LiDAR Quality Assessment Report

GA_SW Georgia 22 County Lidar_2017_B17 - Block 2

NGTOC
 2019-05-22
 S Ruhl

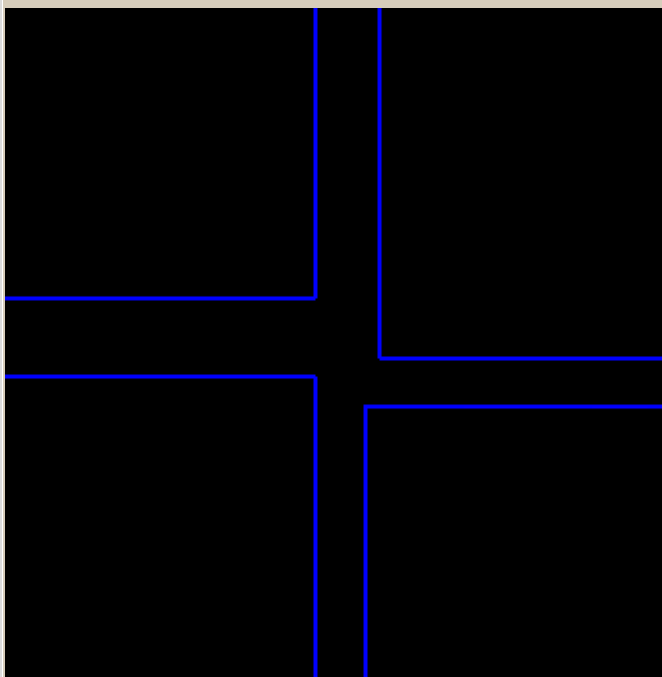
Las Tiles GAW_20650540 and GAW_21950495 have classes 0-31. Please re-process.

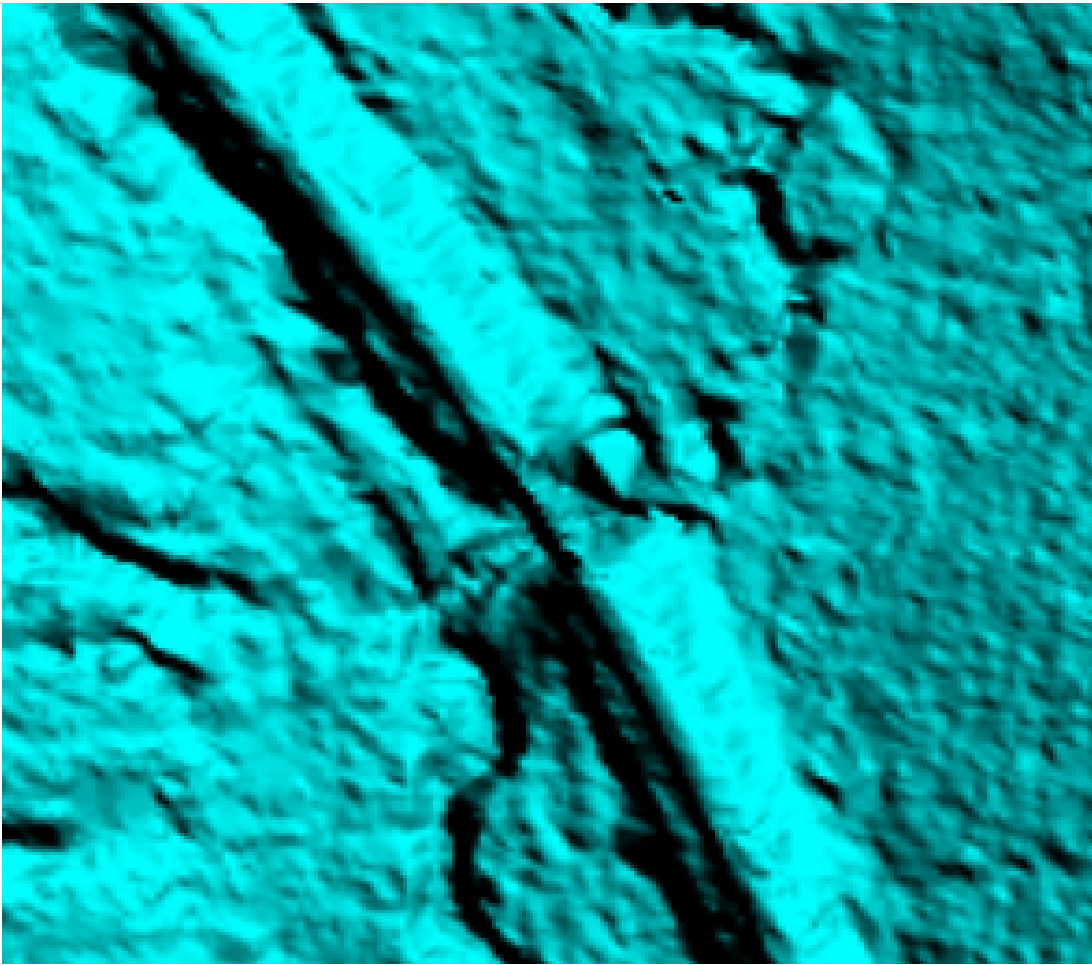
1 - missing complete grid @ 30° 54' 49.4479" N, 84° 30' 52.4381" W

CORRECTED

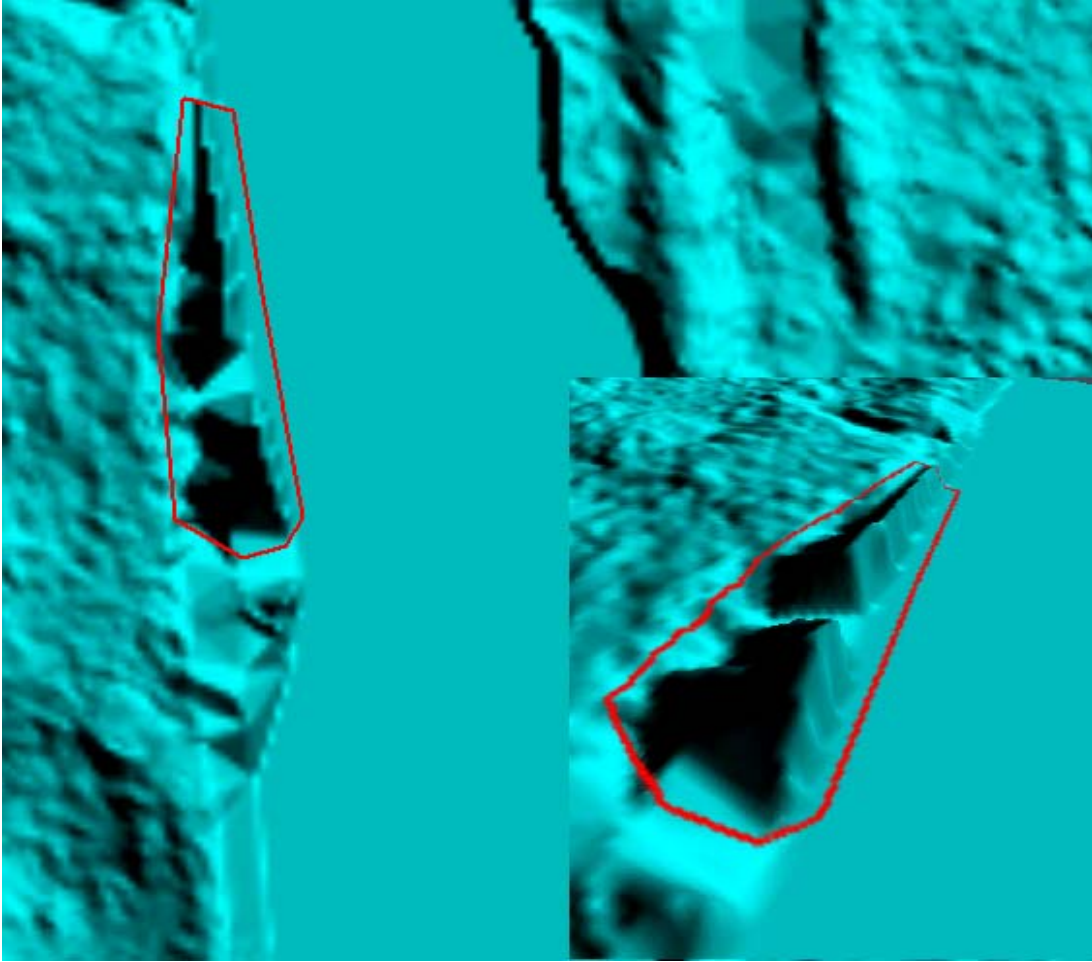
1 - finish removal or replace ground points on track @ $30^{\circ} 47' 35.9702''$ N, $84^{\circ} 31' 12.5191''$ W
CORRECTED

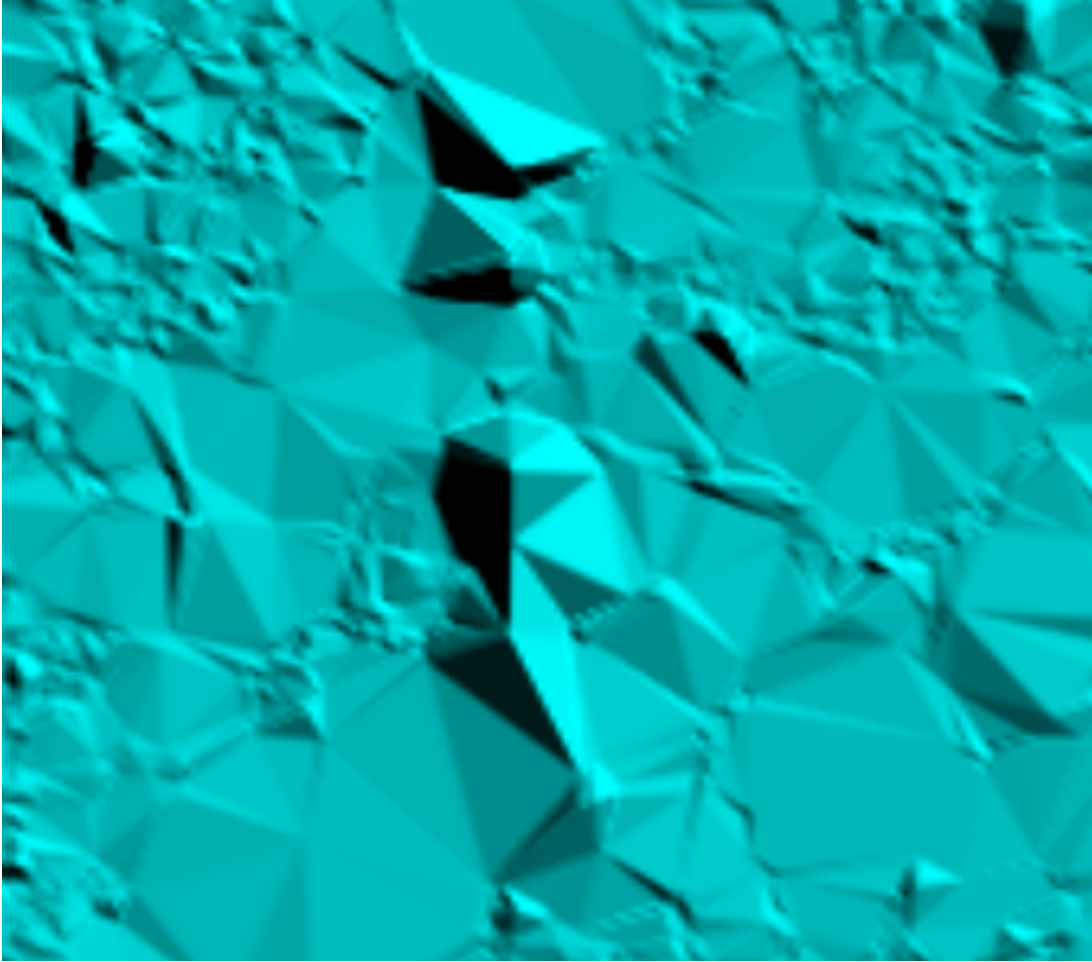
1 - check classification @ 30° 54' 12.2356" N, 84° 44' 59.0097" W
CORRECTED

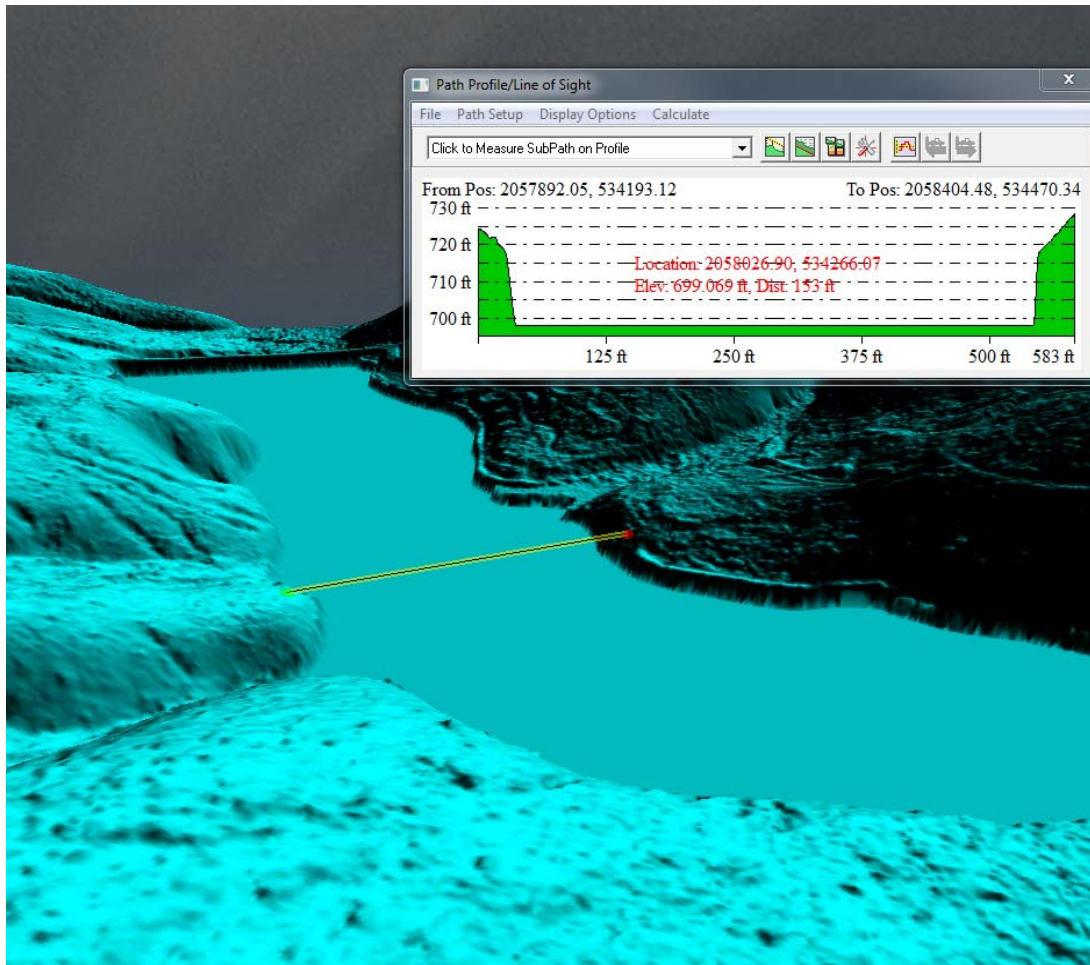
1 - shoreline 2 deep @ 31° 28' 00.8803" N, 84° 55' 53.1104" W
approx. 20' too deep

CORRECTED

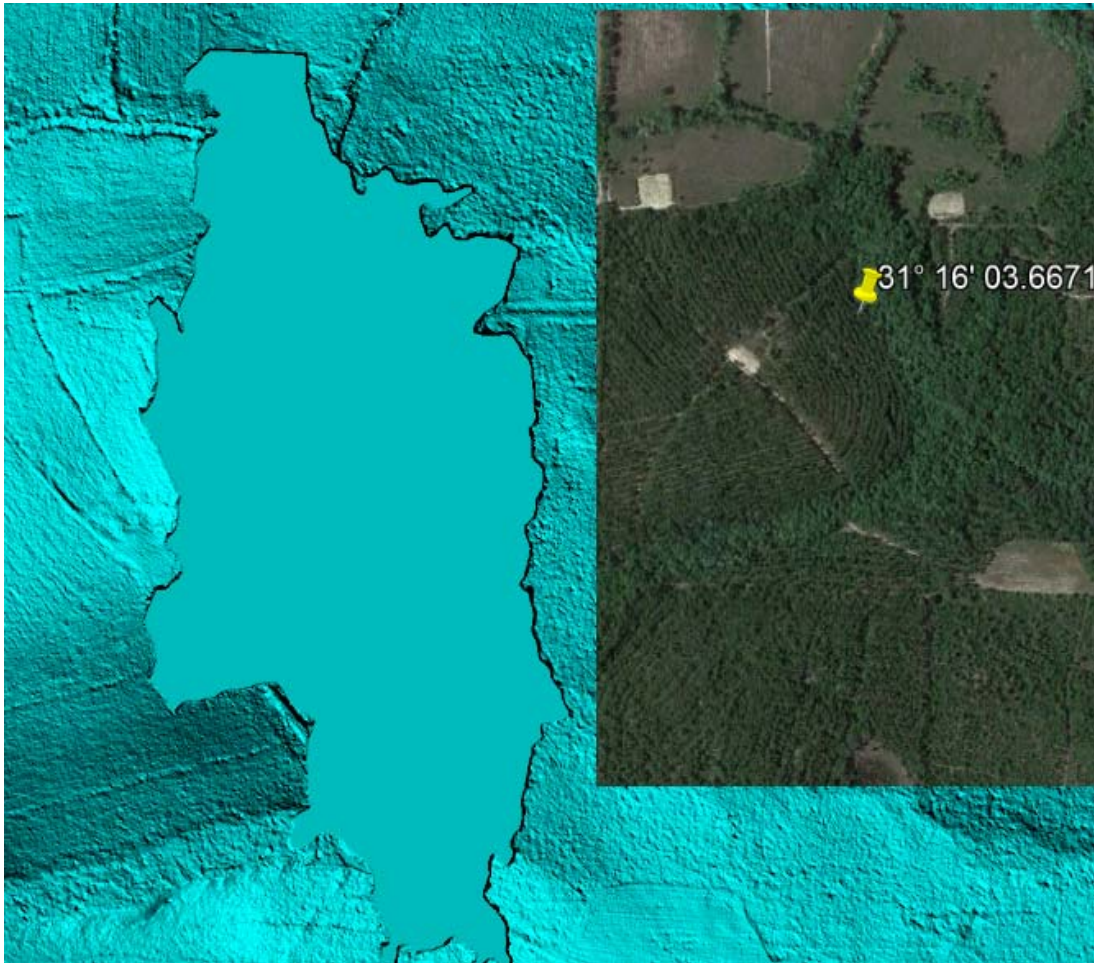
1 - replace ground points on road @ 31° 08' 52.9875" N, 84° 49' 31.1351" W
CORRECTED

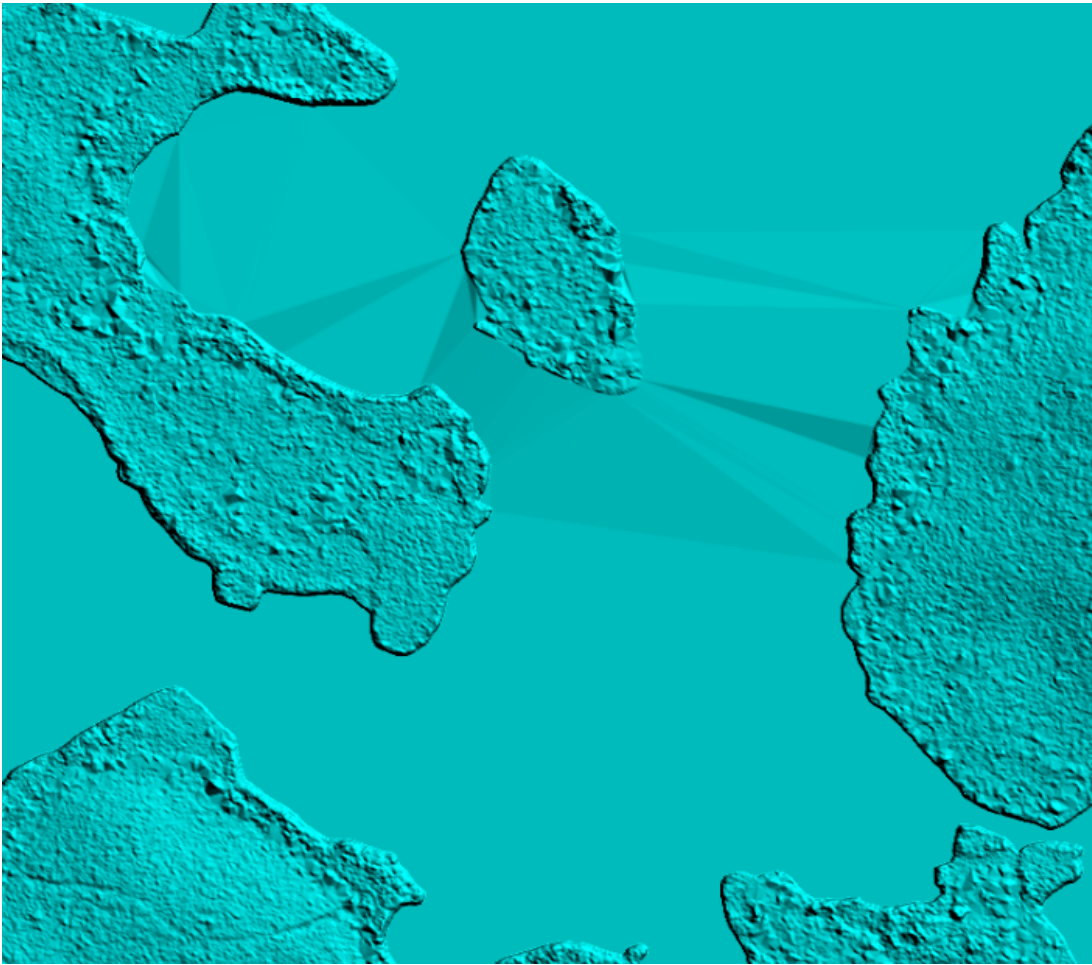
1 of 3 not water - un-flatten @ 31° 16' 03.6671" N, 85° 05' 00.0482" W
CORRECTED

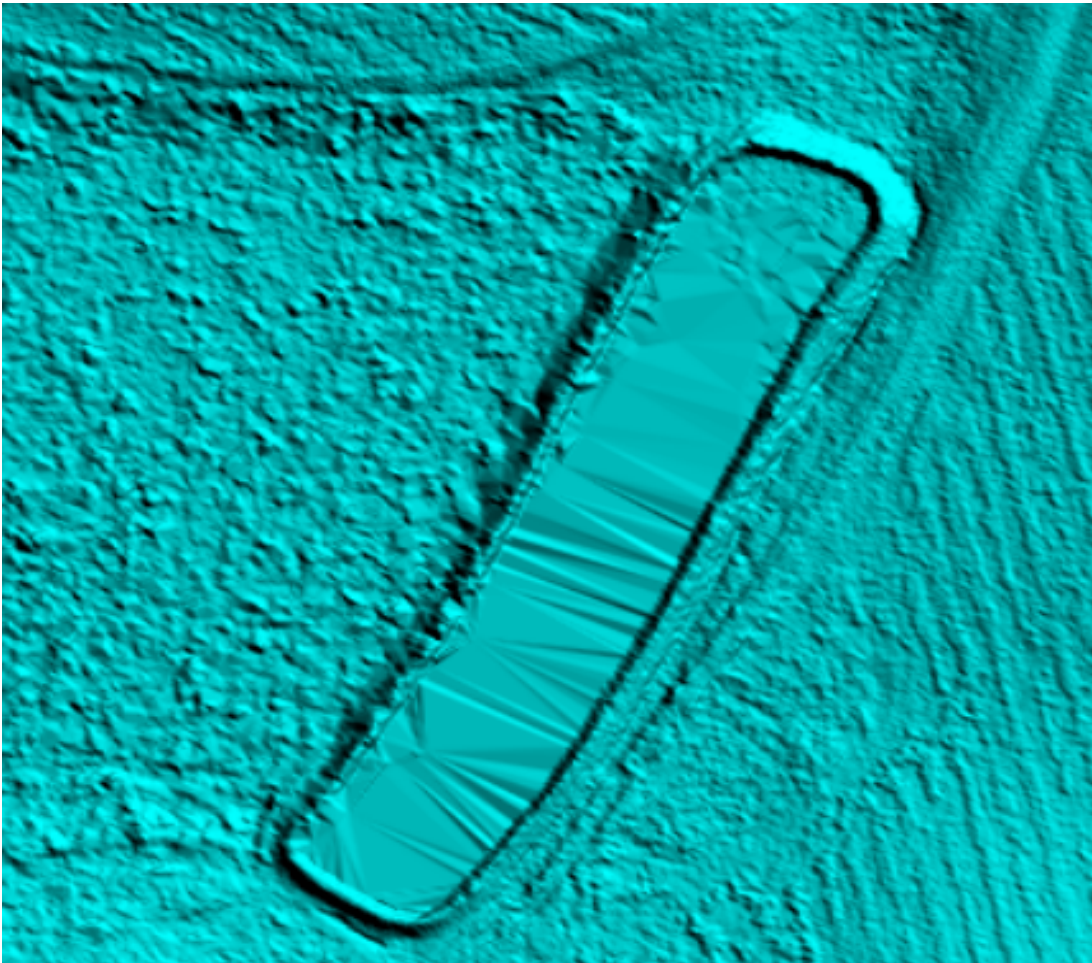
1 of 3 flatten @ 31° 20' 45.3272" N, 84° 58' 22.4874" W

CORRECTED

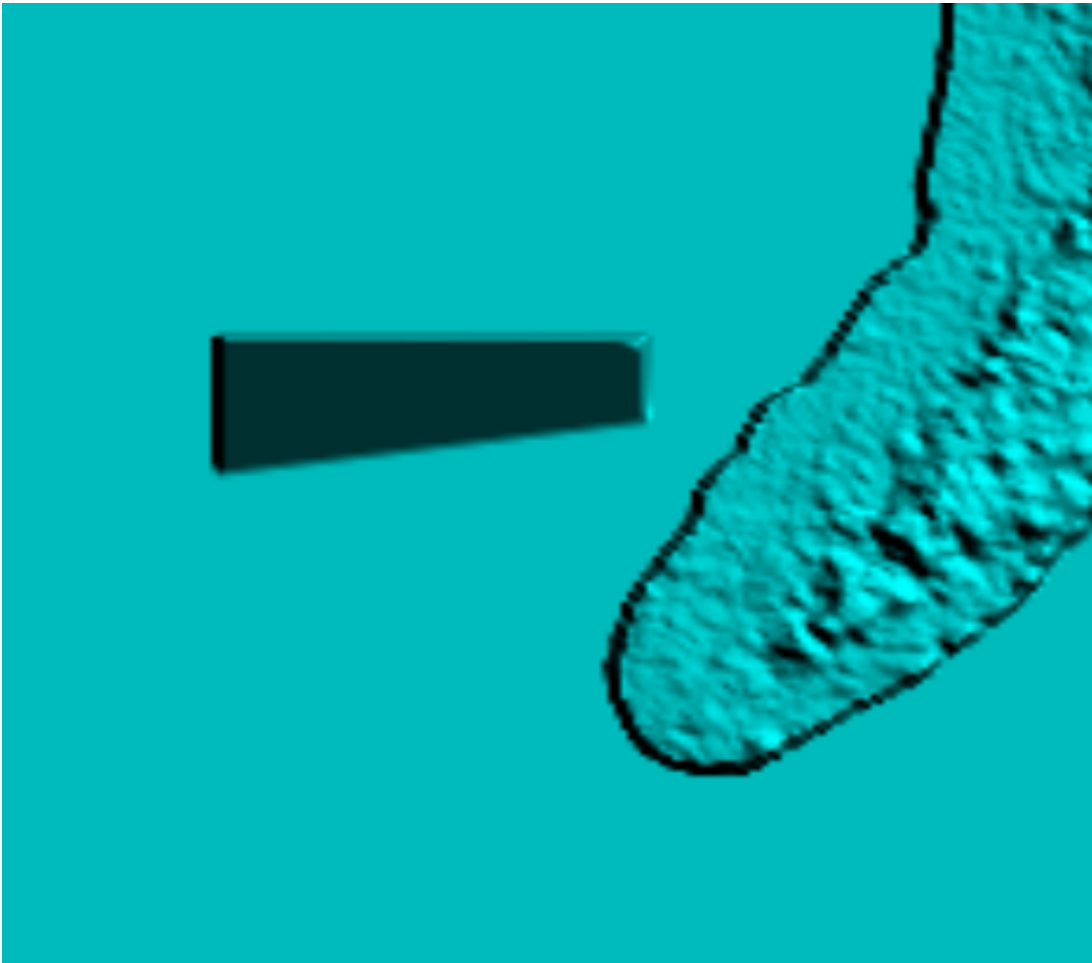
1 of 3 re-flatten @ 30° 46' 23.4706" N, 84° 51' 31.0172" W
CORRECTED
